SITE NAME:  
FOUNTAIN VALLEY  
SITE ID:  
COUG000-RELO  
COLO6000  
13250 RAY NIXON RD.  
FOUNTAIN, CO 80817  
EL PASO

NEW NORTHEAST  
ELEVATION

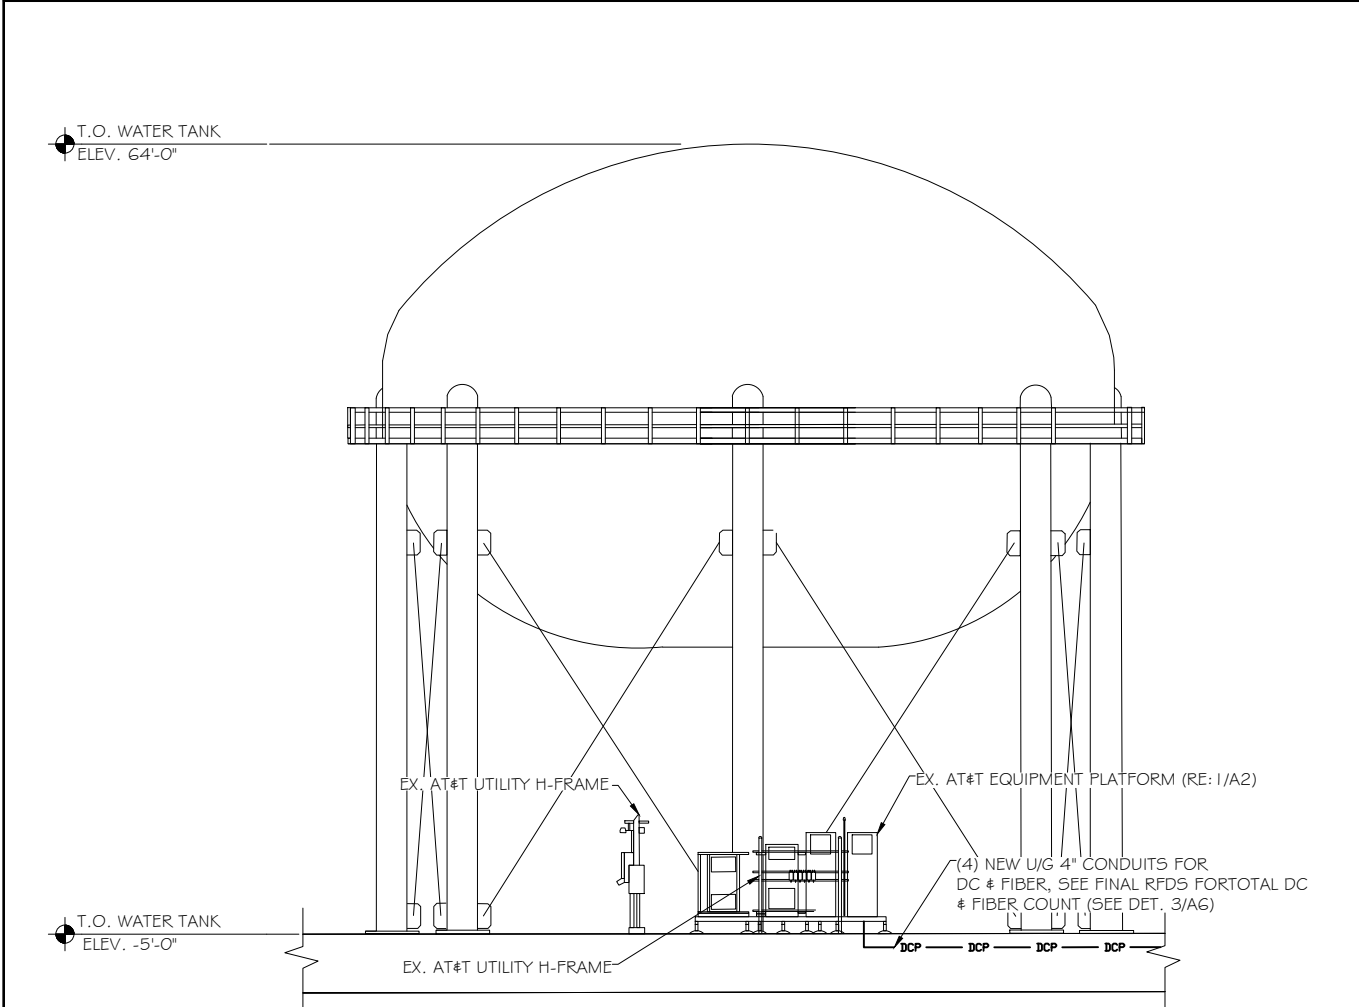
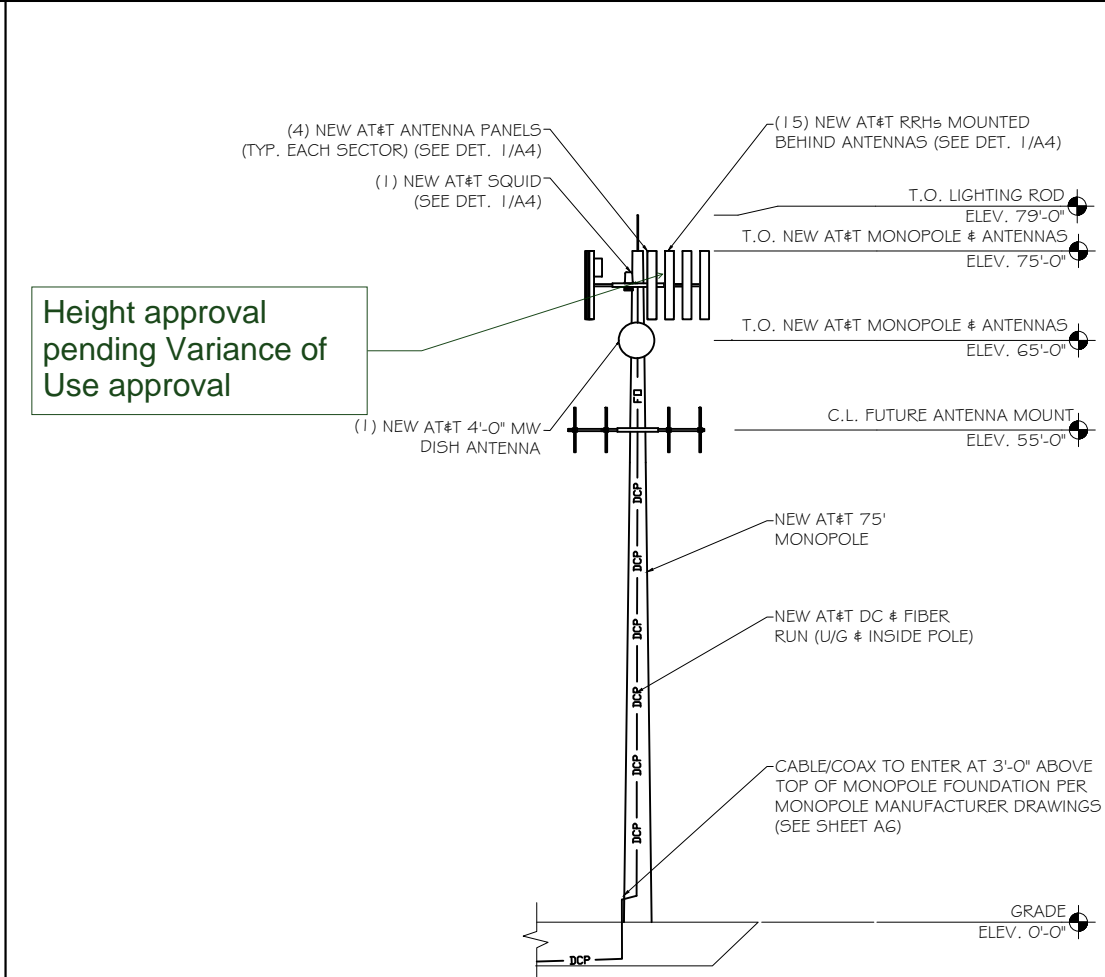
Height approval pending Variance of Use approval
